SUBMISSION

NorthConnex SSI 13_6136

Community Against
Polluting Stacks

Figure 1: Portal placement. NorthConnex proposed portal ★ CAPS proposed portal ★

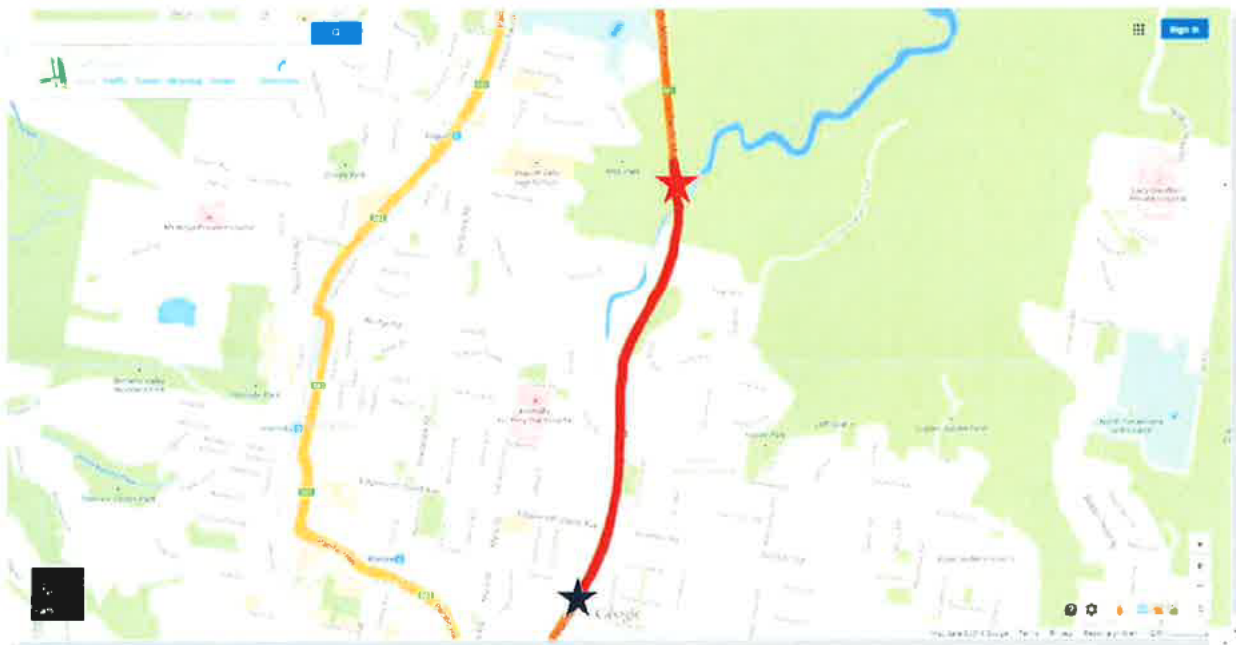
- Portal emissions can adversely impact air quality for about 100-200 metres around them. By locating the M1 exit portal at least 200 metres from residential areas, this will eliminate any potential impacts from portal emissions.
- Portal emissions will occur during emergencies and potentially will involve the uncontrolled discharge of toxic smoke from burning vehicles and tunnel infrastructure into residential areas.
- Portal emissions during normal operations of the tunnel have not been ruled out in the future. If portal emissions are planned during normal operations they need to be moved away from residential areas to protect the communities health.

Figure 3: Position of CAPS proposed portal ★, with exhaust stack ■ vented into Ku-Ring-Gai National Park

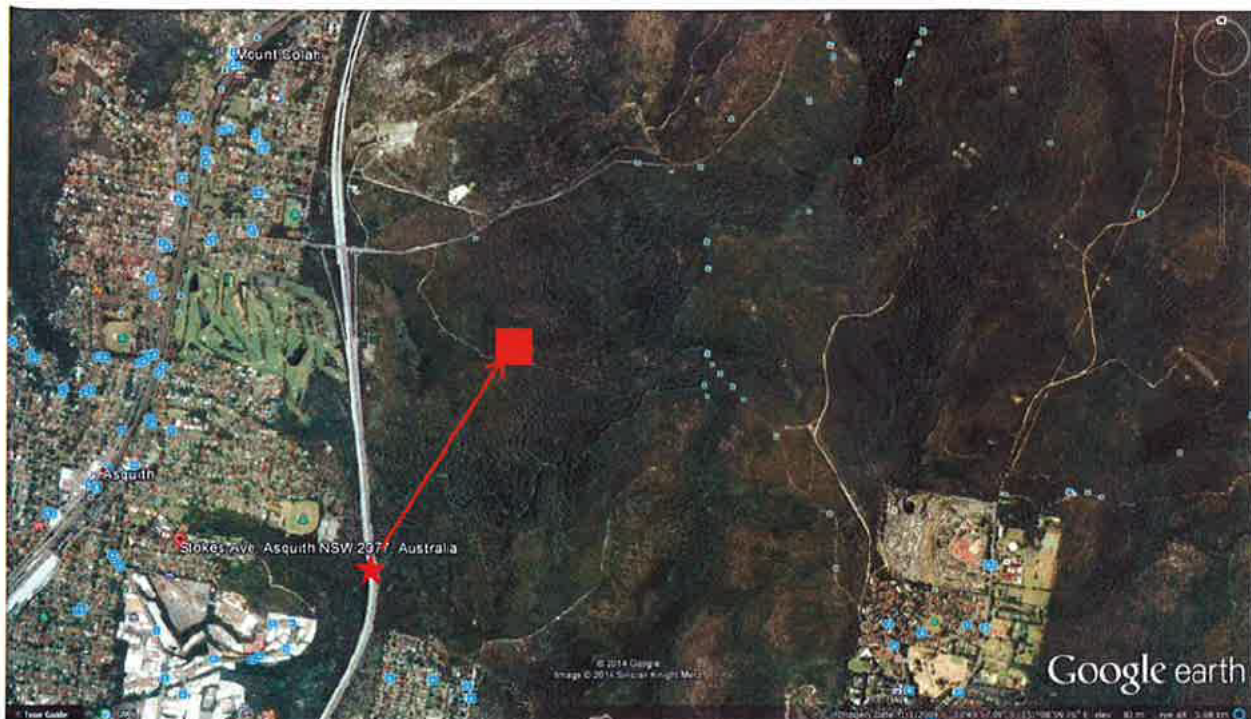
Moving the stack north east of a revised M1 exit portal location to Ku-Ring-Gai Chase National Park would provide a significant buffer to residential areas. Currently there is already a 330kV power line within the National Park and the area of disturbance associated with the stack construction would be substantially lower than a 330 kV power line.

15.3.5 Zero grade tunnel

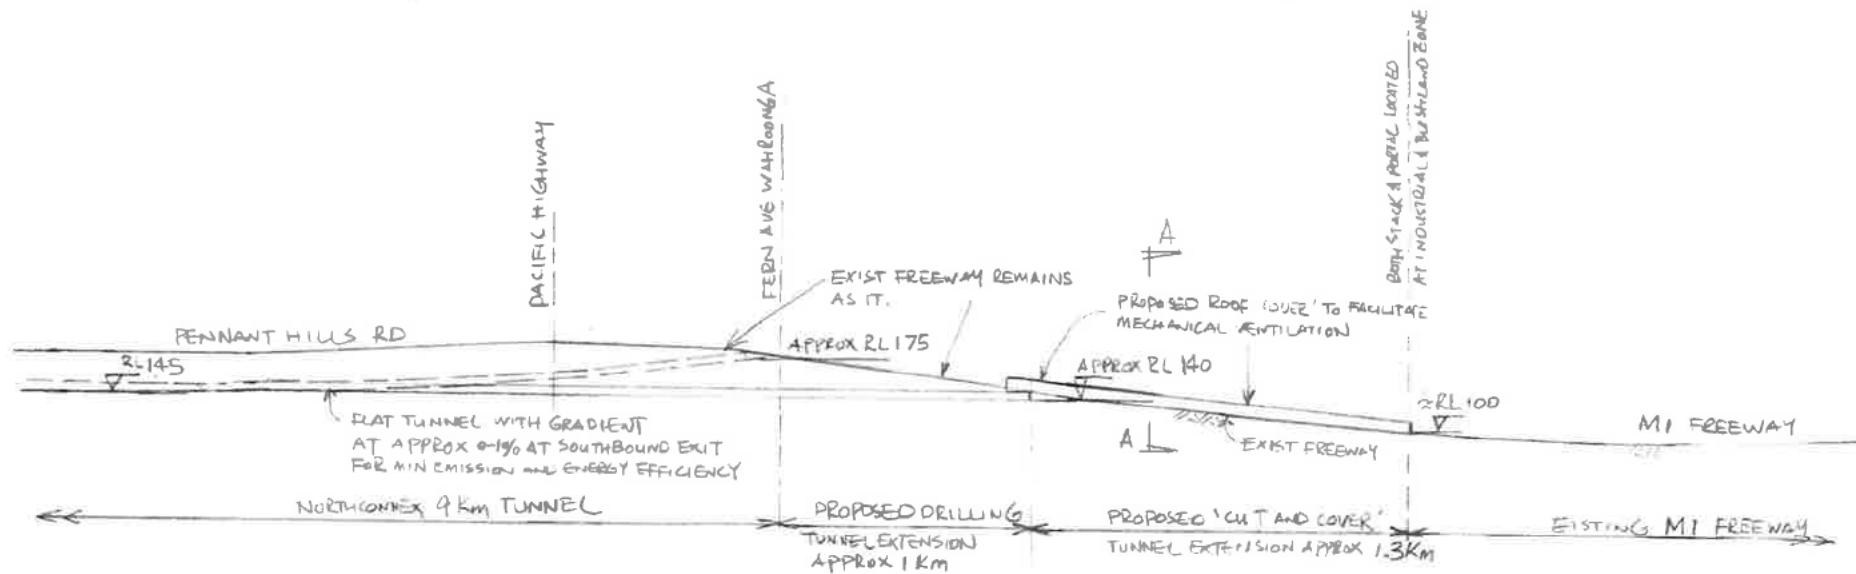
The geological long section of the tunnel presented in Appendix D of the EIS shows that the tunnel from the M2 portals (at about 123 metres RL) dips significantly below the proposed NWRL (to an RL of about 75m) before rising to about RL 175 at the M1 portals in Wahroonga. Because of this significant sag in the tunnel, both southbound and northbound vehicles experience high road grades – which result in the generation of significantly higher quantities of pollutants.

A much better solution would be to reduce the grade to as close to zero as possible. While this is not possible with the M1 portals being located in Wahroonga, however, if the portals were located on the M1 in line with Stokes Avenue in Asquith (which is about RL 121 metres), a zero grade tunnel at approximately 120 metres RL becomes a closer reality. The only issue is the interface with the NWRL and a low point just north of the M2. A more complex tunnel alignment and construction methodology would be required in this area (with NorthConnex going over the NWRL slot rather than under), however, there is no technical reason why this could be achieved. As the NWRL would not be an operational rail line (and NWRL tunneling may not have even reached this location by the time NorthConnex starts tunnel construction), the construction and safety risks are significantly reduced.

ALTERNATIVE 'CAPS' PROPOSAL FOR 'CUT & COVER'
TUNNEL EXTENSION AT WARRINGGA
AT 21/8/14

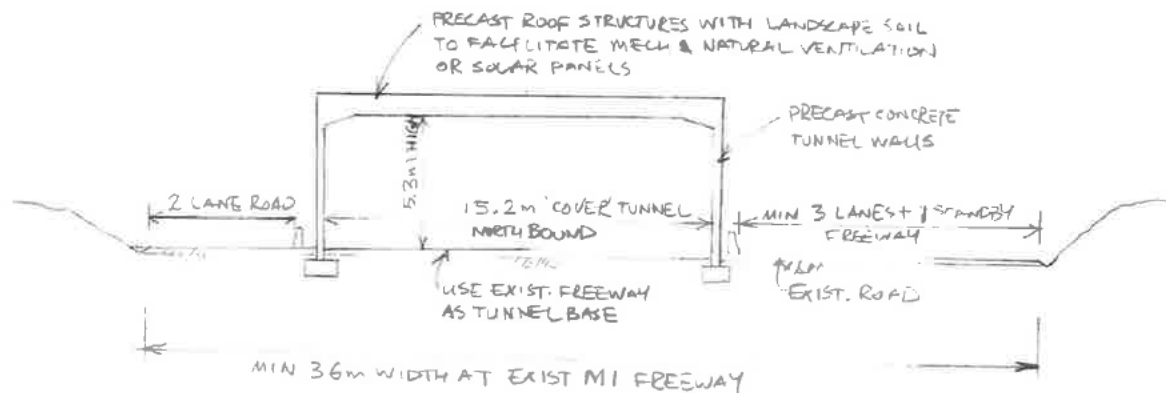
Another alternative to extend the tunnel further north would be to cover the existing M1 with a concrete structure. Basically once the tunnel reaches RL 140 metres instead of continuing to tunnel up to RL170 metres at Woonona Ave, a flat tunnel would be constructed which would exit about 1 kilometre north of the currently proposed M1 exit portal location. For another kilometre the tunnel could be extended using an above ground concrete tunnel. The cost of this type of construction would be significant lower than underground tunneling (about 75% lower) – and appropriate safety and egress requirements could be easily implemented. A diagram showing the concept is presented on the following page.
